Form 3160-5
(June 2019)

SUNDRY NOTICES AND REPORTS ON WELLS
Do not use this form for proposals to drill or to re-enter an abandoned well. Use Form 3160-3 (APD) for such proposals.

Betty 5 Fed Com 103H (FKA Getty 5 Fed Com 764H) API #: 30-025-52104

EOG respectfully requests an amendment to our approved APD for this well to reflect the following changes:

WELL LOCATION AND ACREAGE DEDICATION PLAT

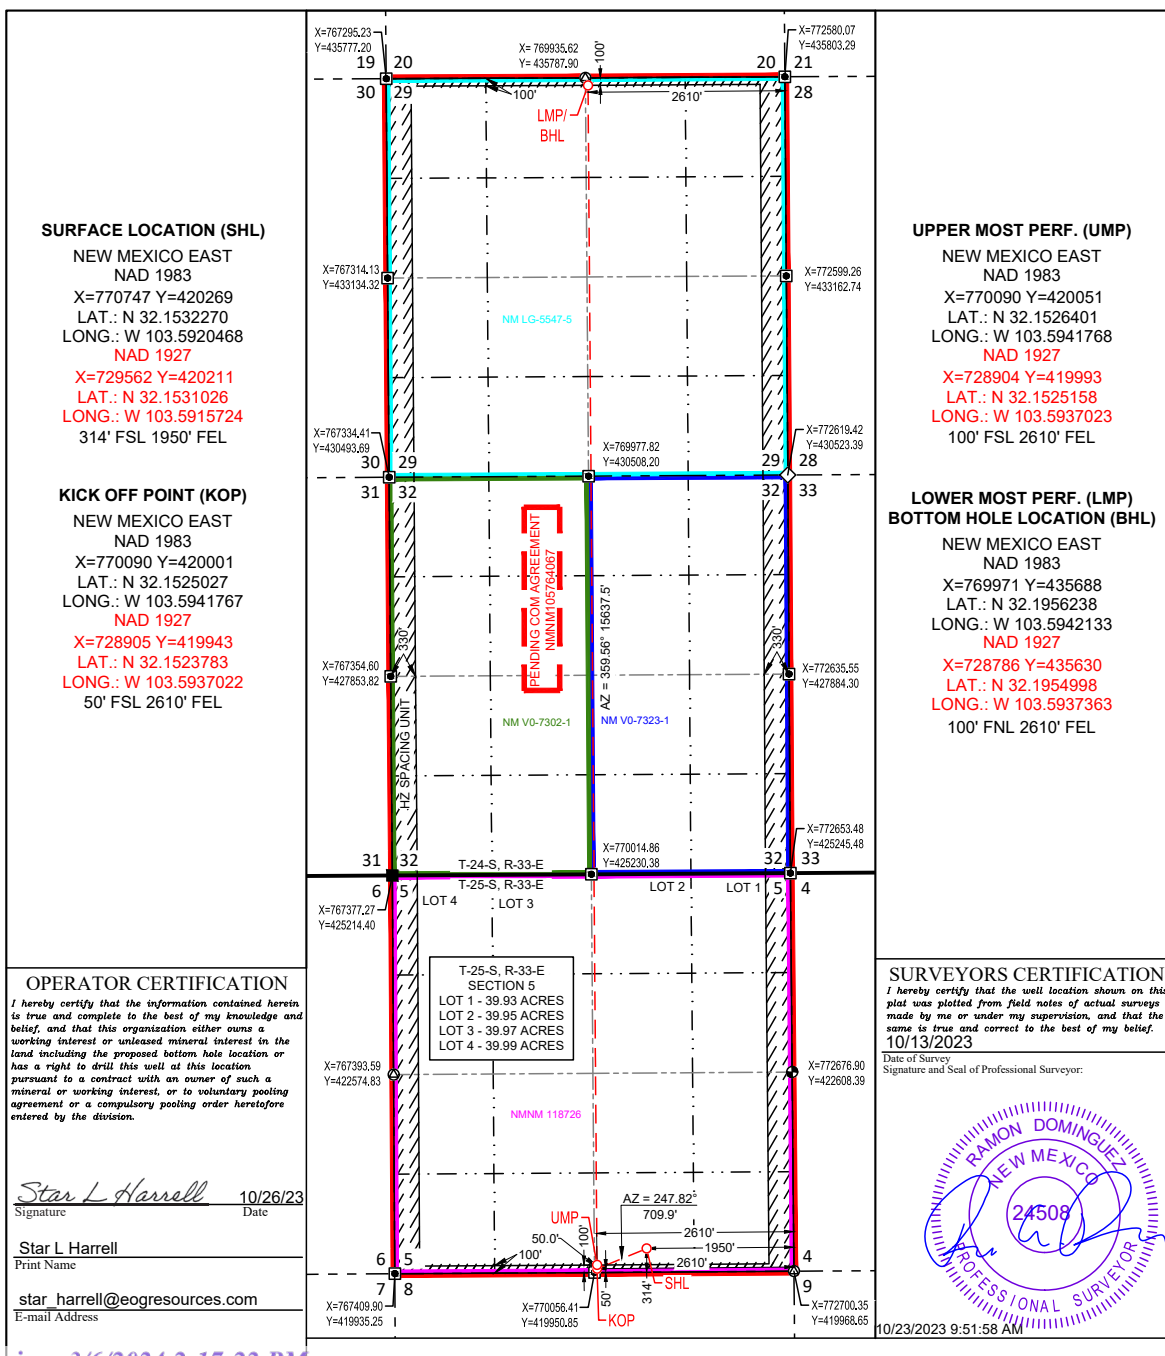
Change name from Getty 5 Fed Com 764H to Betty 5 Fed Com 103H.

Change SHL from T-24-S, R-33-E, Sec 5, 1327' FSL, 1878' FWL, Lea Co., NM, to T-25-S, R-33-E, Sec 5, 314' FSL, 1950' FEL, Lea Co., N.M.

Change BHL from T-24-S, R-33-E, Sec 32, 2539' FSL, 716' FWL, Lea Co., NM, to T-24-S, R-33-E, Sec 29, 100' FNL, 2610' FEL, Lea Co., N.M.

Update the Pool as reflected in the C-102.

UL or lot no.	Section	Township	Range	Lot Idn	Feet from the	North/South line	Feet from the	East/West line	County
O	5	25-S	33-E	-	314'	SOUTH	1950'	EAST	LEA

UL or lot no.	Section	Township	Range	Lot Idn	Feet from the	North/South line	Feet from the	East/West line	County
B	29	24-S	33-E	-	100'	NORTH	2610'	EAST	LEA
Dedicated Acres 1919.84	Joint or Infill	Consolidated Code	Order No.	PENDING COM AGREEMENT NMNM105764067

Proposed 11" Hole with 9.625" 40# J55/HCK55 LTC Casing

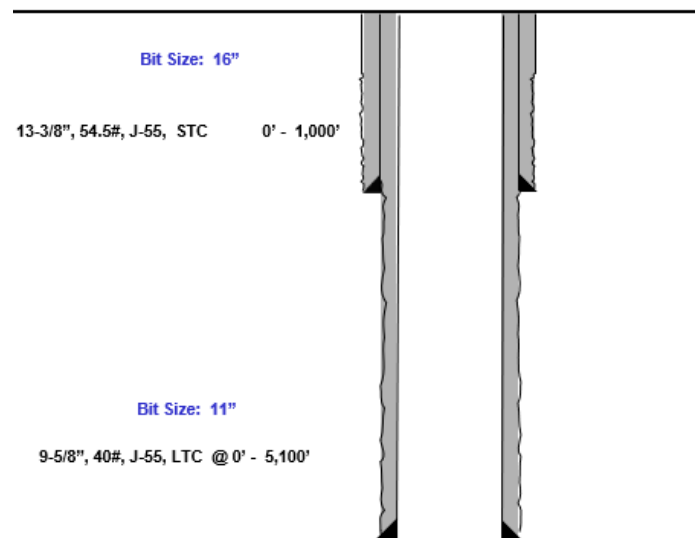
EOG request permission to allow deviation from the 0.422" annulus clearance requirement for the intermediate (salt) section from Onshore Order #2 under the following conditions:

- 11" Bit + 0.52" Average hole enlargement = 11.52" Hole Size
 - 0.9475" Clearance to casing OD
